PRAIRIE ISLAND NUCLEAR GENERATING PLANT

**Additional Information on Proposed Revision to Main
Steam Line Break Methodology Dated June 26, 1997**

Outline for Discussion with NRC on MSLB Submittal, 4/16/99

**Responses to the questions asked during the MSLB NRC conference
call on April 16th 1999**

Core Response With & Without Decay Heat

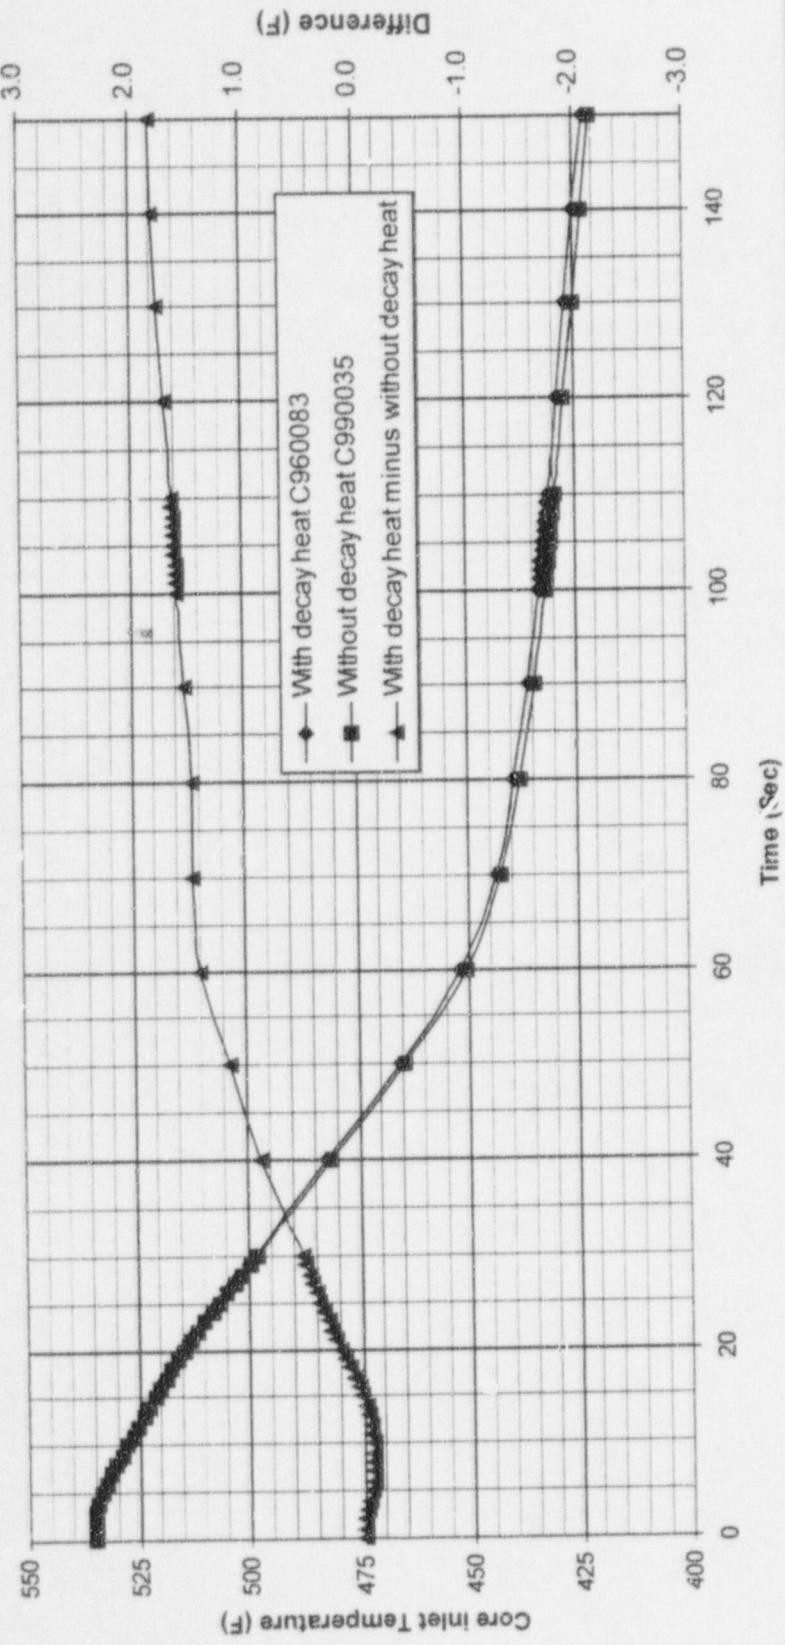
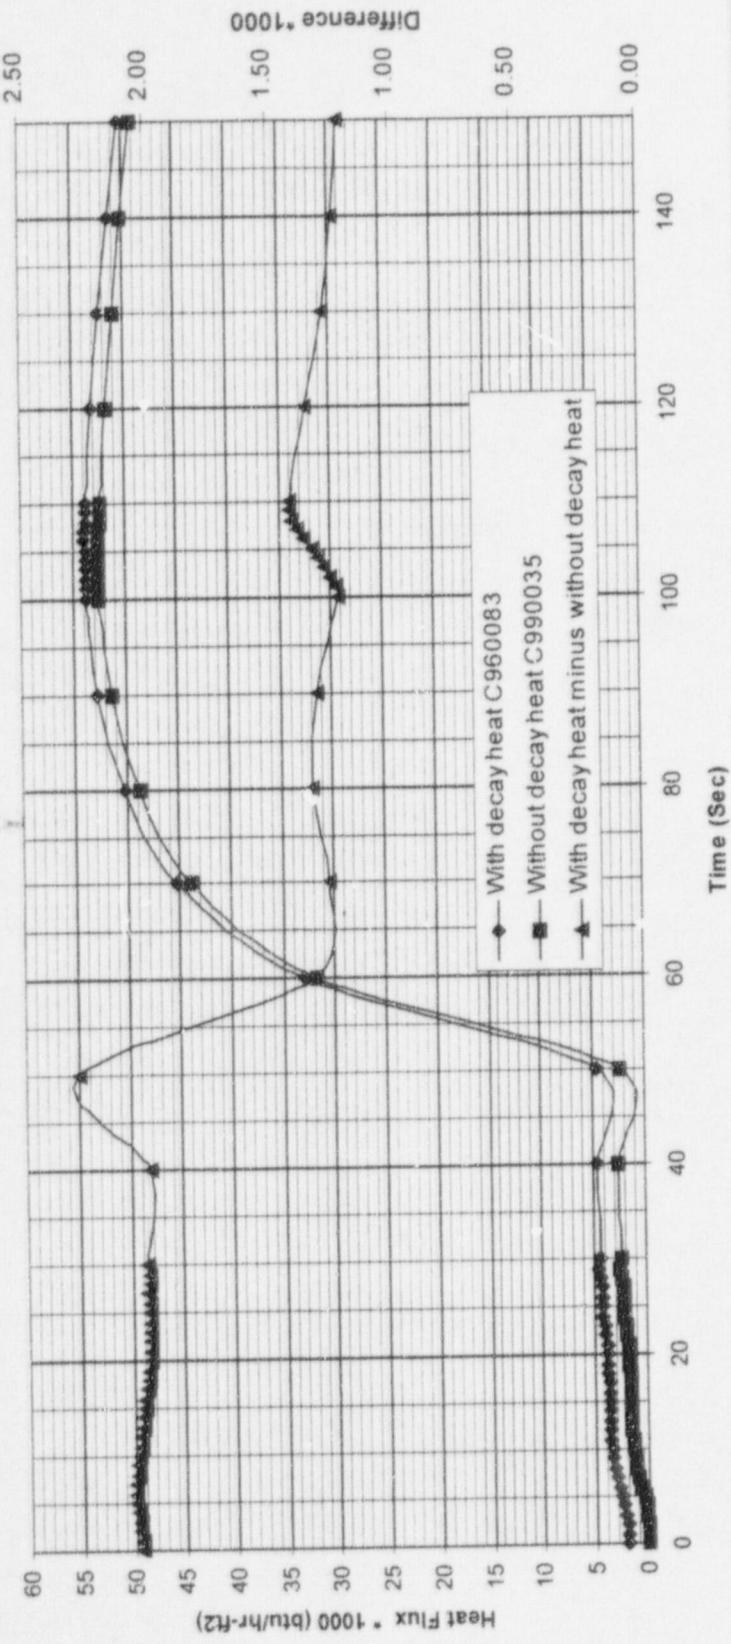
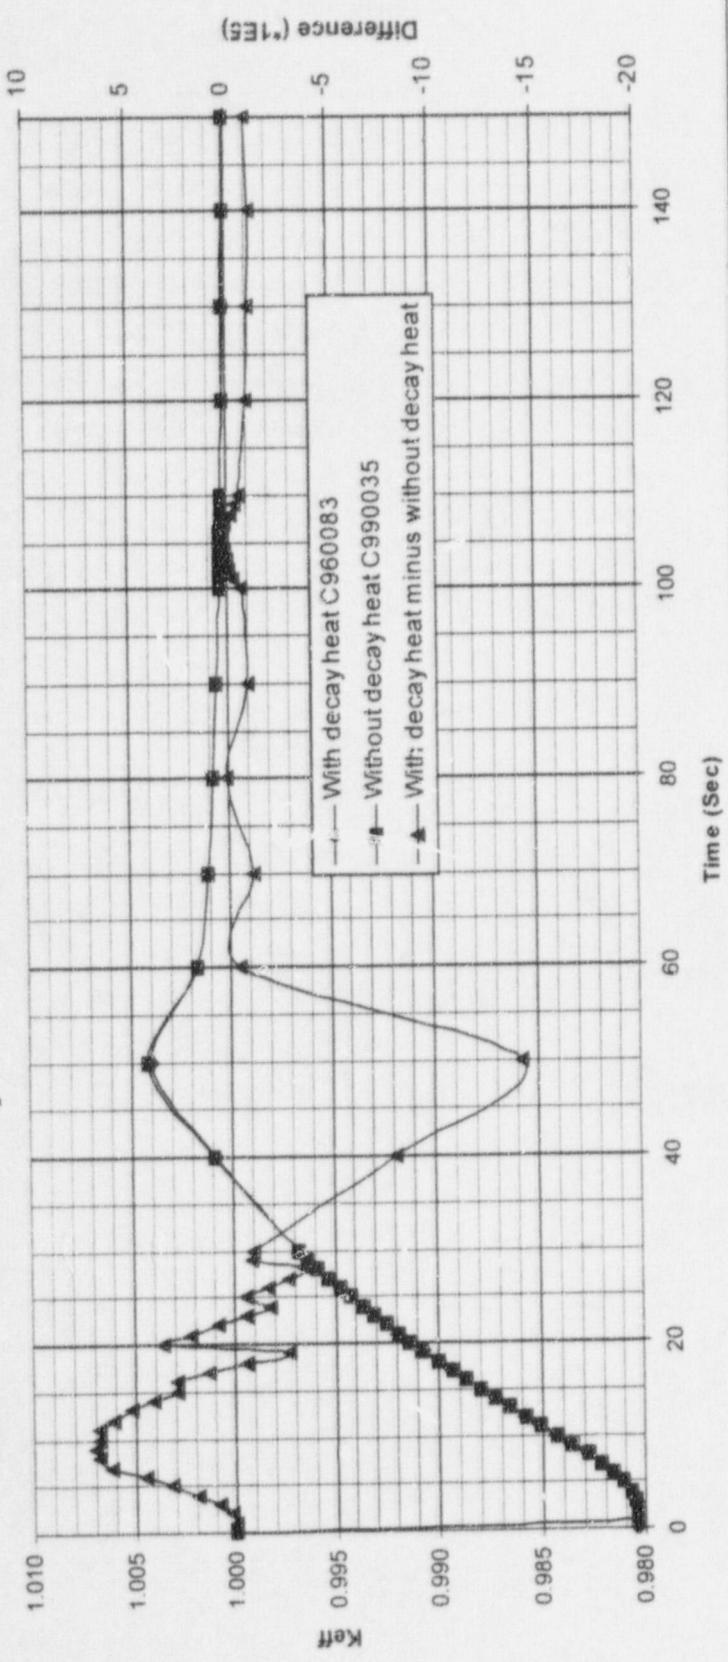
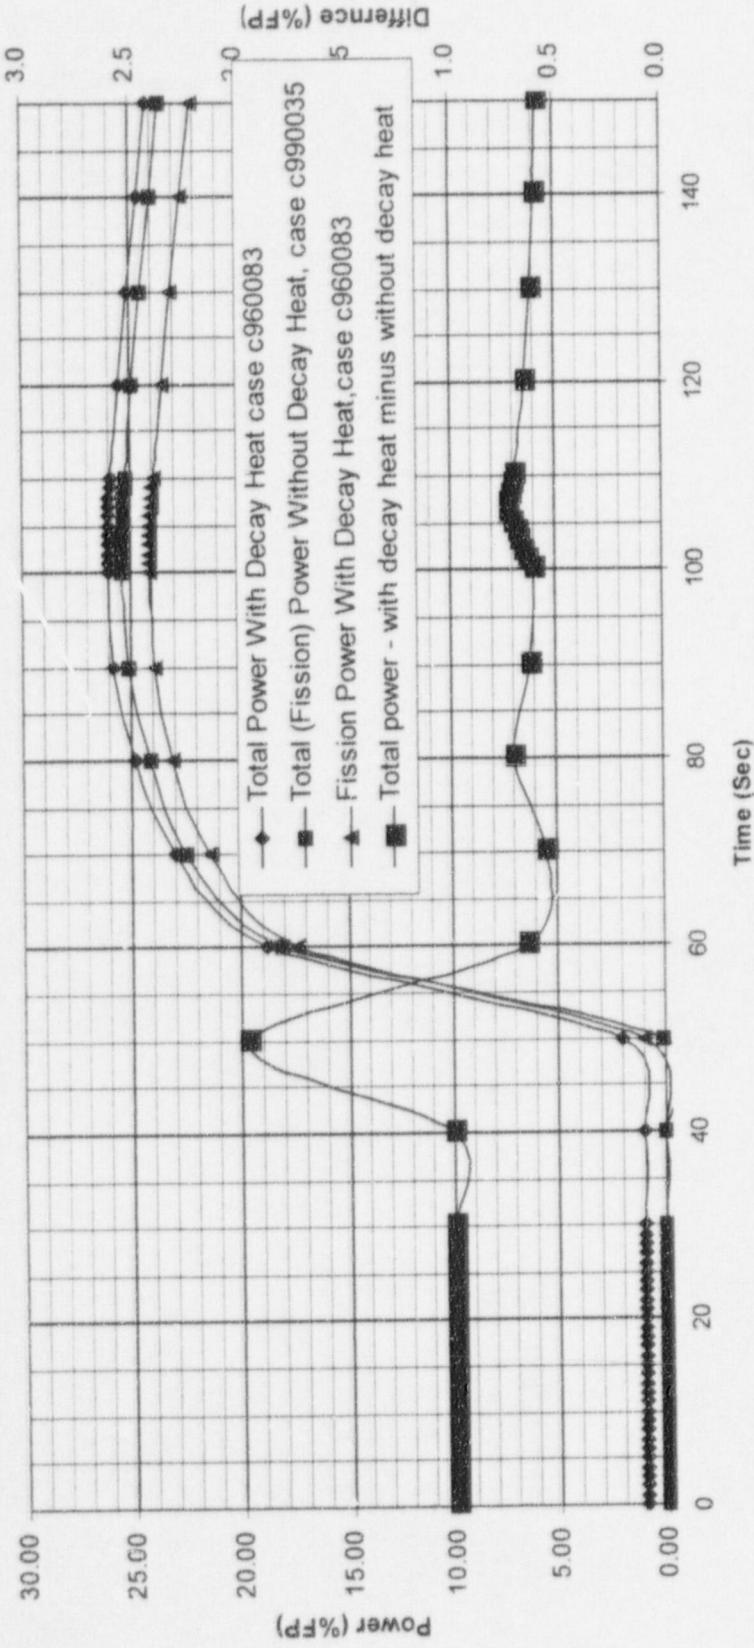
For the Core response cases with and without decay heat, please provide plots of the differences in parameters.

When the sensitivity case without decay heat was run, only the input parameters necessary to remove decay heat were changed. Because the feedwater flow inputs were not changed to correspond to the lower initial power, the code initialized the feedwater enthalpy to an extremely high value. This resulted in less cooling during the first few seconds of the transient, but had very little impact on the overall cooling and thus the MDNBR. However, the sensitivity was rerun adjusting the feedwater flow such that it provided the same cooling as the case that did model decay heat. The results of the new case was a MNDBR of 2.334 which is higher (i.e. less limiting) than the MNDBR when decay heat is modeled (2.232). This demonstrates that modeling decay heat is conservative. The attached are plots comparing the new case with that in NSPNAD-97002.
